Docket Item #17
BAR CASE #2004-0140

BAR Meeting
August 18, 2004

ISSUE: New multi-family residential & retail building

LOCATION: 806-828 S Columbus Street and 712-728 Jefferson Street

Figure 1 Entry section from 2003 approved concept drawing

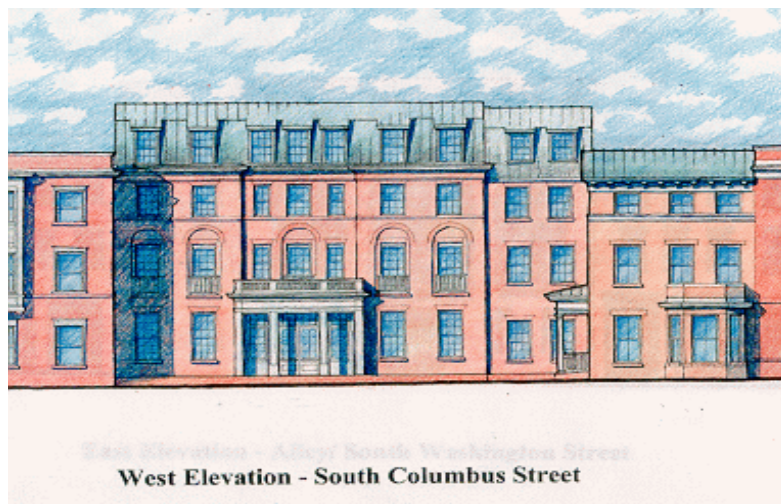
The center entrance section has been somewhat simplified and the proposed color has been changed. In the 2003 proposal the second level windows had arches above the lintels and a brick beltcourse was proposed between the second and third levels. The arches above the windows have been eliminated and replaced with lintels with keystones. The beltcourse has been removed. The color has been changed from a red brick to a brick with a more brownish hue. The base of the building has also been revised. The 2003 proposal portrayed a plain brick base. The current proposal illustrates a rusticated base with every fifth row of brick recessed. In the opinion of Staff, the current design proposal is acceptable. The revisions to the Colonial Revival design vocabulary create a center section that somewhat differentiates it from the rest of building mass.

Staff does have concerns regarding several elements of this elevation. First, one of the design principles that has guided the overall composition of this elevation was to divide the facade into a series of separate townhouse-like elements so that it reflected the character of the immediately surrounding area. While in large measure this has been accomplished, Staff is concerned that the use of standing seam metal roof for all of the gable roofs along South Columbus Street creates a homogenous feeling that detracts from the intended individual townhouse vocabulary. Staff suggests that the roofing material for the center entry section be reconsidered and that slate or a

faux slate roof material be installed on this section to create visually separate element.

Second, Staff notes the change in brick color of the center entry section, but finds the change quite subtle. Staff believes that additional differentiation would be achieved if this entry section were to be of painted brick. Specifically, Staff believes that painting this center section a yellow color would contribute to the elegance of the revised facade.

Finally, Staff has concerns about the one story bay section immediately to the south of the entrance. Visually, the base of this bay section appears to be inadequate to support the bay above; it is almost as if the bottom of the bay had been sunk into the ground. To Staff this is a disconcerting element and further attention should be given to the portion of the elevation.

1. Change of the roof material of the center entry section to slate or faux slate;
2. Consider painting the brick of the center entry section a contrasting color;
3. The projecting first floor bay on the South Columbus Street facade needs further design consideration;
4. Restore the transom on the easternmost building on Green Street;
5. Enlarge the storefront on the easternmost building on Jefferson Street;
6. Detailing of the garage entrance; and,
7. Details of the metal fencing in front of the Green Street English basement apartments and for the garden fencing along South Columbus Street.
